Development Applications Committee

DATE: Tuesday 19 October 2021

ITEM-17 **DAC 19/10/21 - 164 HUNTER STREET, NEWCASTLE - DA2019/00331.01 - SECTION 4.55(2) MODIFICATION TO DA2019/00331 - MIXED-USE (COMMERCIAL, RETAIL & RESIDENTIAL) INVOLVING ALTERATIONS AND ADDITIONS TO HERITAGE LISTED BUILDING - CHANGES TO APPROVED PLANS INCLUDING AN ADDITIONAL STOREY**

Figure 1: Extract of Hunter Street Elevation – red markup shows the alignment and proportions of cladding elements on the addition with the pilasters on the host building below.

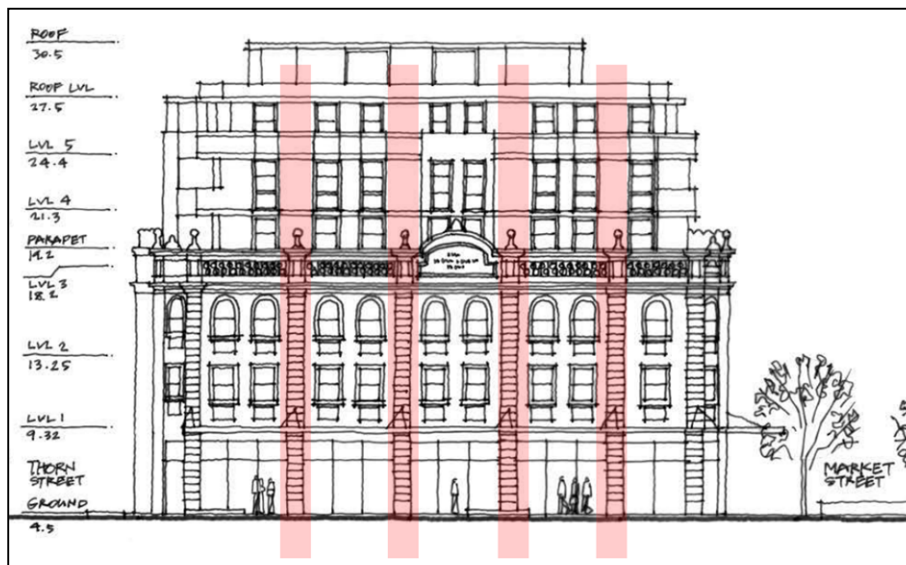
- iii) *To this end, the Panel recommends further amendment of the proposed external massing and expression, including:*
- iv) *Maintaining the established symmetrical articulation of the Hunter Street elevation in the new additions. Breakup of proposed cladding panels, or alternate materials, needs to provide greater engagement between the addition and existing facades.*

The breakup of cladding panels on the proposed addition have been further resolved – vertical joints in the cladding have been aligned to the pilasters of the host building as far as possible. The placement of windows and alignment of cladding panels now achieve greater engagement between the addition and existing facades (see

The shape/ proportions of windows in the proposed addition have been amended to be 'vertical' to provide continuity with the windows of the host building. It is noted that this approach has been applied to not just the Hunter Street elevation, but also the east and west elevations, to better respond to the existing windows within the host building on these facades which is considered positive.

Figure 2: Extract of Sketch demonstrating testing of southeast corner terrace symmetry (Source: de Witt Consulting).

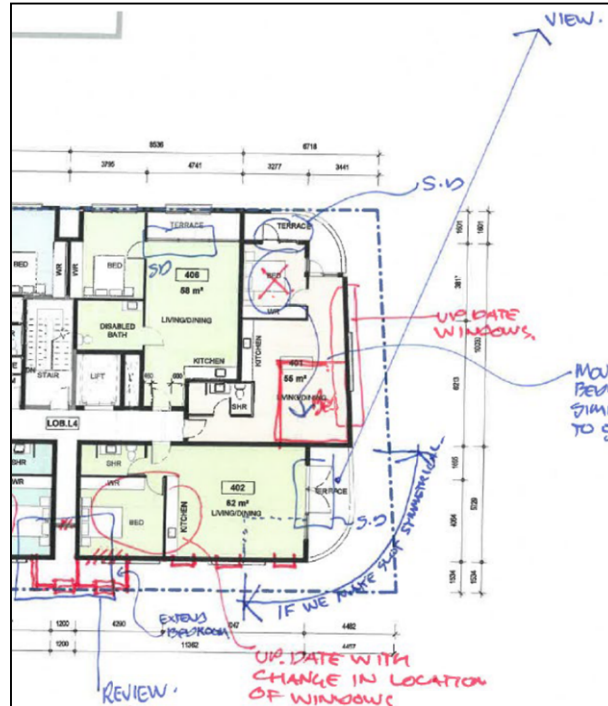
The articulation of the recessed balconies at the south-east corner (Hunter Street and Market Street) was tested by the applicant and proved to be unworkable for several reasons. To make the opening for the recessed balcony symmetrical about the corner of the host building would mean extending the balcony approximately 3m along the Hunter Street elevation (see **Figure 2** below). This would reduce the internal area of these southeast apartments to an unacceptable size and significantly impacted on the useability and functionality of the internal space.

Furthermore, extending the opening for the balcony along the Hunter Street elevation also significantly reduced opportunities to provide the symmetry and 'rhythm' to the Hunter Street facade of the proposed addition which is needed to achieve greater connection and continuity with the host building. Reducing the length of the opening for the recessed balcony along the east facade as way of then reducing the impact on the Hunter Street elevation (still trying to achieve the symmetry about the corner of the host building) was also tested. However, this would restrict access to the northeast aspect and views across to the harbour, and as such considered unsatisfactory.

On balance, CN considers the applicant has demonstrated considerable and meaningful effort to redesign the approved building to provide an improved development that strengthens the dominance of the host building, despite the additional level sought by the modification application.

Figure 3: Extract of approved and modified Hunter Street Elevation (Source: BN Architecture) – red markup shows the alignment of 'central' window element in the addition and the curved pediment on the host building for both the approved development (right) and modified development proposed (left).

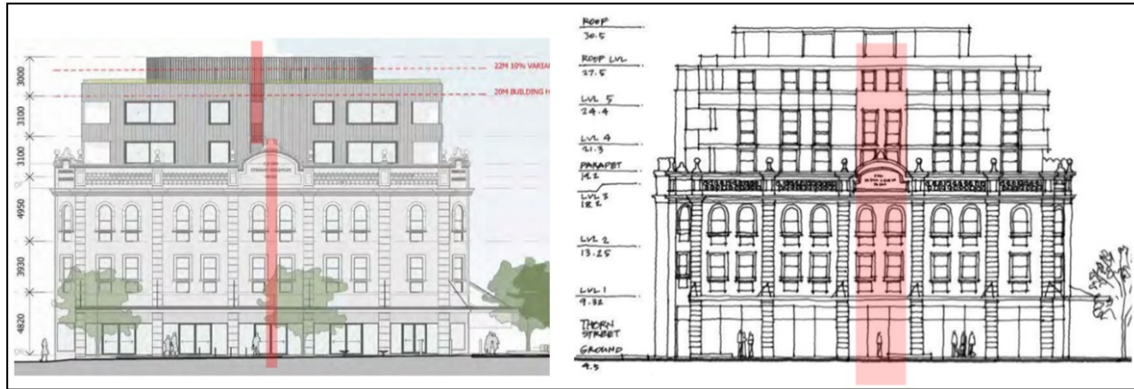
The slot window to the lift lobby/ hallway of the apartment levels of the proposed addition have been incorporated into a small 'pop-out' element on the Hunter Street elevation that aligns with the central curved pediment on the host building below. The placement of windows within the 'pop-out' element, matches with the host building below.

Importantly, it is noted that the placement of the slot window to the lift lobby/hallway of the new addition as approved is not symmetrical in any form. Furthermore, the new addition as approved provides zero connection to the symmetry of the curved pediment, 'rhythm' of the window bays, or repetition of the pilasters of the Hunter Street elevation in the host building.

The modified development is an important improvement on the current approved development in this respect. The 'pop-out' element to the proposed addition now acts as a 'central' element that aligns with the curved pediment element of the host building within the Hunter Street elevation, and in doing so, provides a continuity in form and massing between the two (see **Figure 3** below).

Figure 4: Extract of Level 5 Floor Plan (Source: BN Architecture).

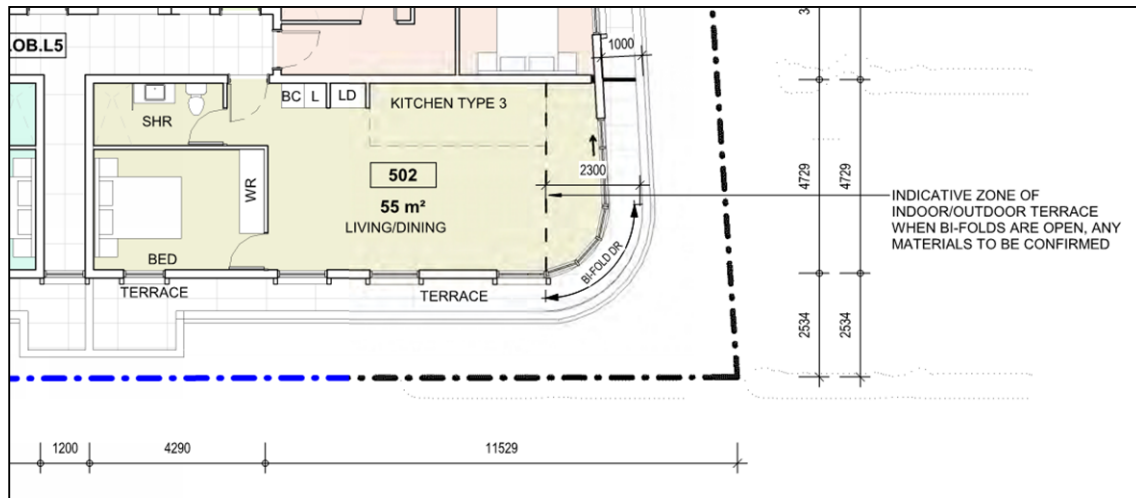
- i) Rooftop communal area –the indoor area should be decreased, and the treatment of landscaping increased.*
- ii) Proposed balconies are undersized. Whilst not insisting on ADG compliant areas for the original heritage building component, better use could be made of narrow balconies. If greater access to these were available from the interior. On Level 5 balconies, the single hinged door access from the living/ dining area is not supported. Amendments are required to provide a usable link between internal and external areas.*

The bi-fold door arrangement on Level 5 makes better use of the narrow balconies

– when open, an indoor/outdoor area with a depth ranging from 2.3m – 2.4m is provided (see **Figure 4** below).

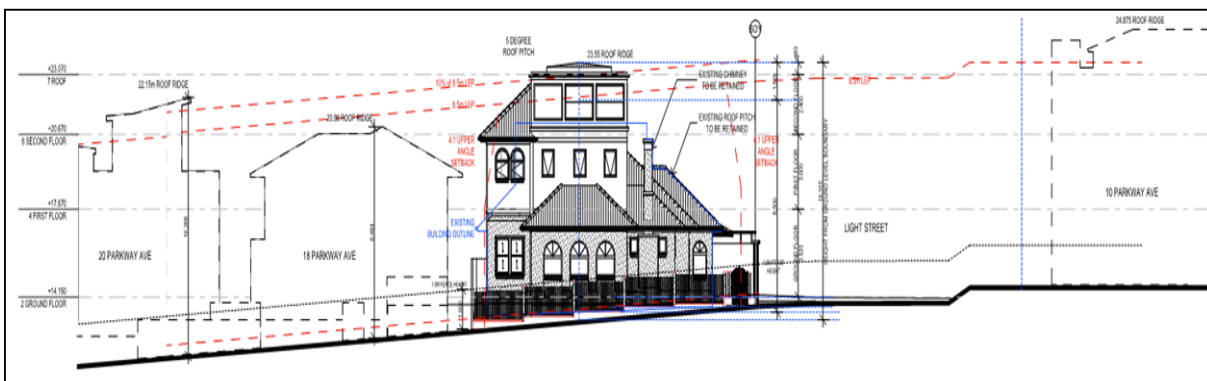
CN assessing officers did not support the original design as the proposed variation was seen as too excessive and requested that the design be reviewed to better address the NLEP 2012 Height of buildings principal development standard and reduce bulk and scale.

In response to concerns raised by CN assessing officers, the original proposal was amended, replacing the hipped roof over the rooftop terrace with a lower profile, flat roofed design, which can be seen in the diagram below.

Building height exceedance high-lighted in yellow – South elevation

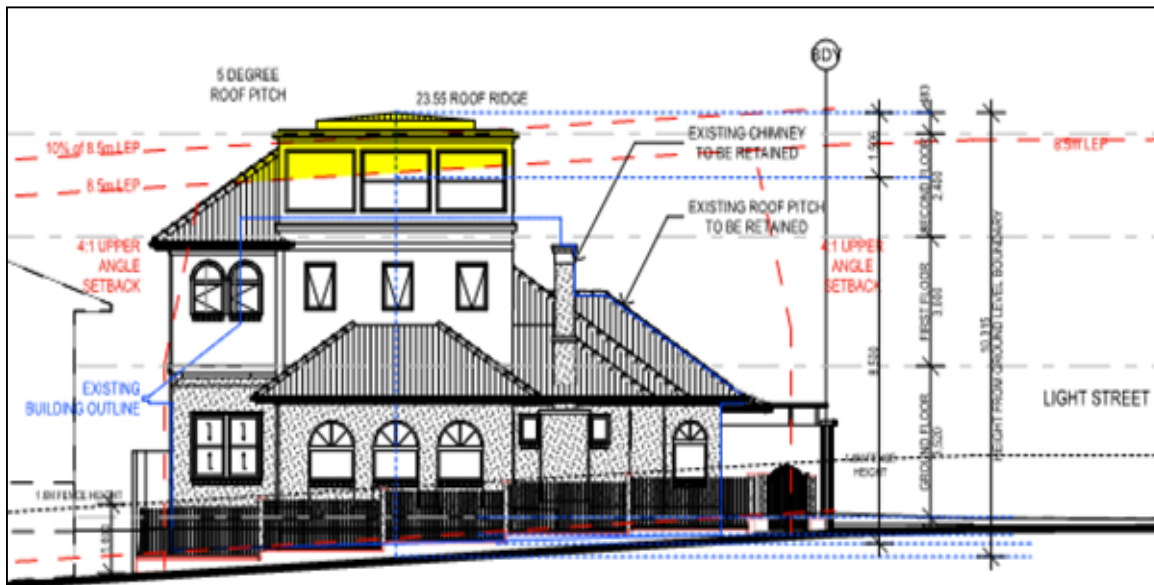
The proposed development will result in a maximum height of 10.315m, equating to an exceedance of 1.815m or 21.35% above the height of buildings development standard, as depicted below.
